CONSTRUCTION OF
PAVED
SIDEWALK/ DRIVEWAY

Application No. 11746

Address: 251 Belleville Rd New Bedford

Driveway Review Form

Driveway Review

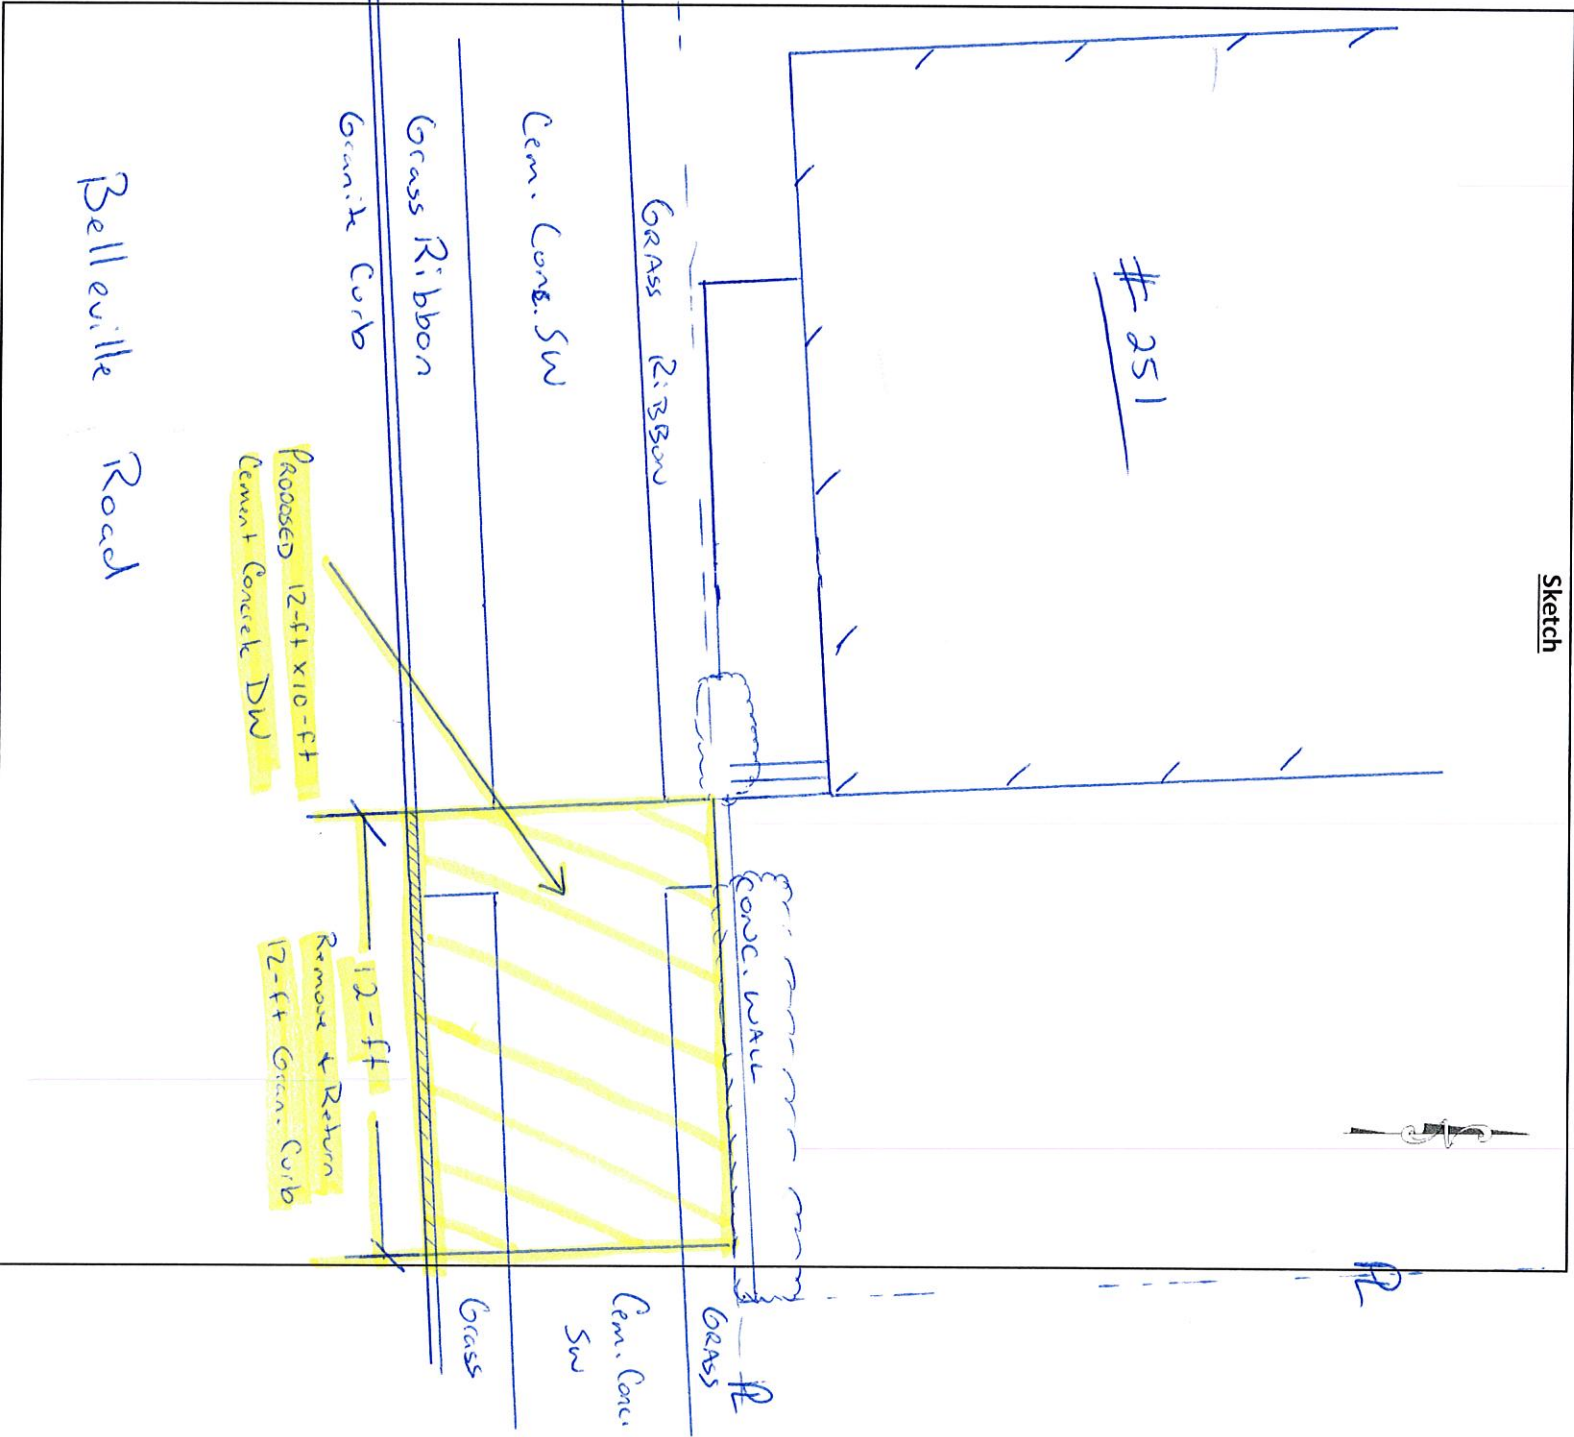
Additional Inspection Notes: 1.Curb return above. 2.Remove 12-ft x 10-ft cem.conc.sidewalk and grass ribbon area. 3.Install new 12-ftx10-ftx6-in cem.conc.driveway apron in accordance with the most current revision of DPI Specs.

Note: Contractor must meet slope requirements for driveway apron, which may require the removal and replacement of abutting sidewalk panels.
